City of Richmond
Urban Development Division

Report to Committee

Re: **APPLICATION BY GRANDSPAN DEVELOPMENT LTD. FOR REZONING AT
4791 STEVESTON HWY. FROM SINGLE-FAMILY HOUSING DISTRICT,
SUBDIVISION AREA E (R1/E) TO COMPREHENSIVE DEVELOPMENT DISTRICT
(CD/135)**

(RZ 01-198910)
File: 2060-20-7391 **Ref:** 8060-20-7392

SITE PLAN

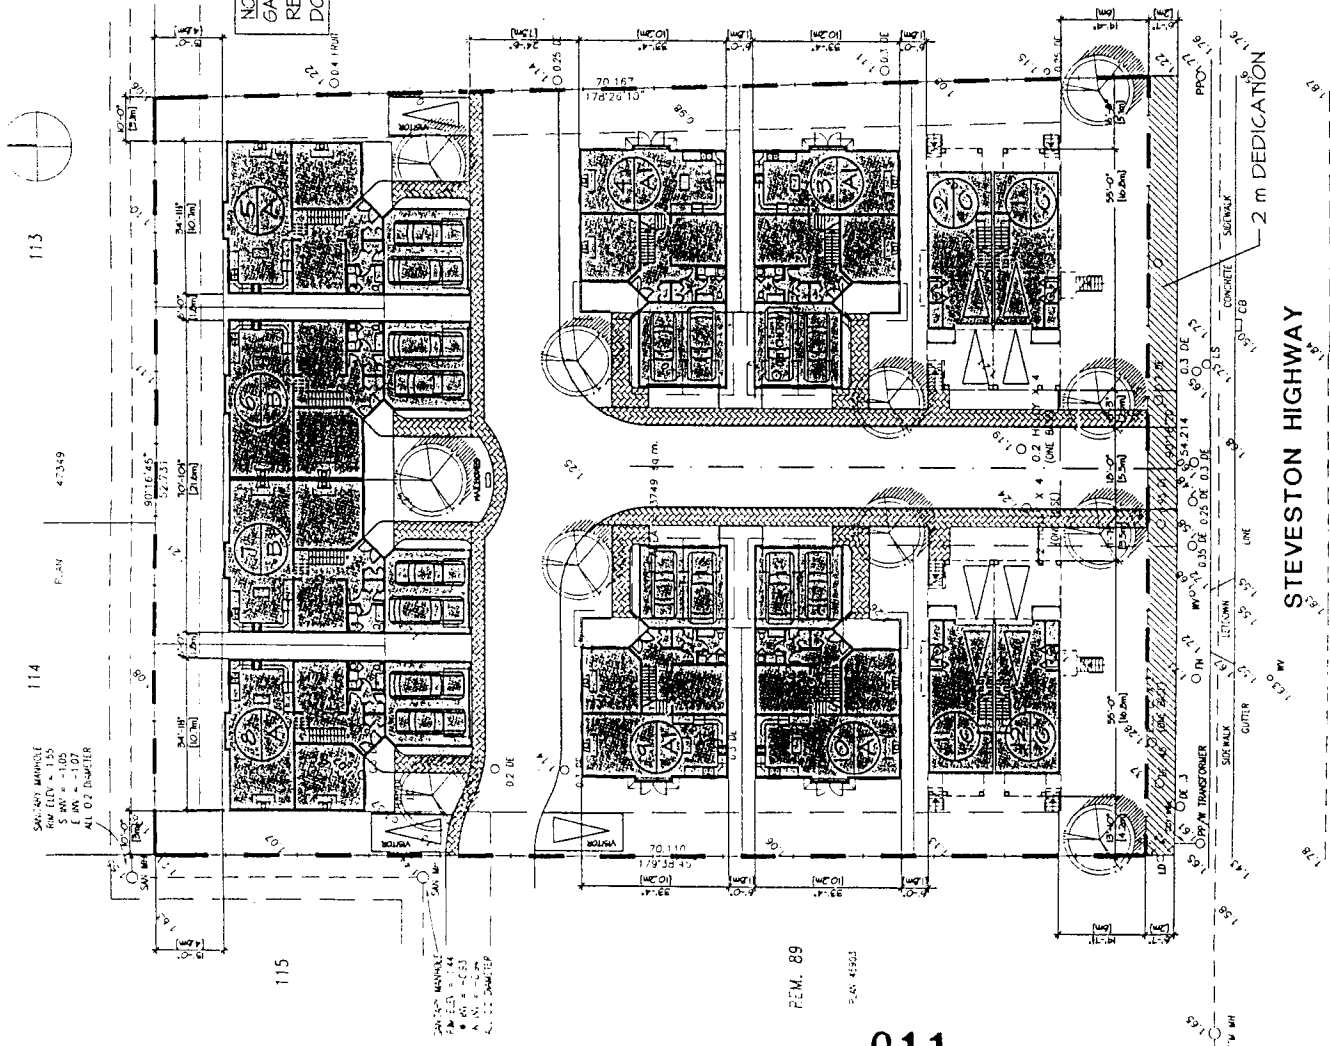
The comments below are based upon the applicant's site plan dated May 24/02 showing 12 units on strata title, 8 units single family character and 2 duplexes (4 units). These design related comments can be addressed through the Development Permit application/servicing agreement stage or earlier. The applicant should:

- Show turnaround capability for all three of the visitor parking stalls (e.g. hammerheads);
- Remove bulge around the mailbox area that encroaches into the laneway;
- Ensure only one vehicular access to Steveston Hwy.;

- Design and provide a “driveway” crossing at Steveston Hwy.;
- Note that for travel lanes, 5.5 m acceptable, however additional width may be required for other purposes (e.g. utilities, lighting, etc);
- Provide a 2 m road dedication required along Steveston Highway;
- Provide a sidewalk that is separated from the travel lanes.
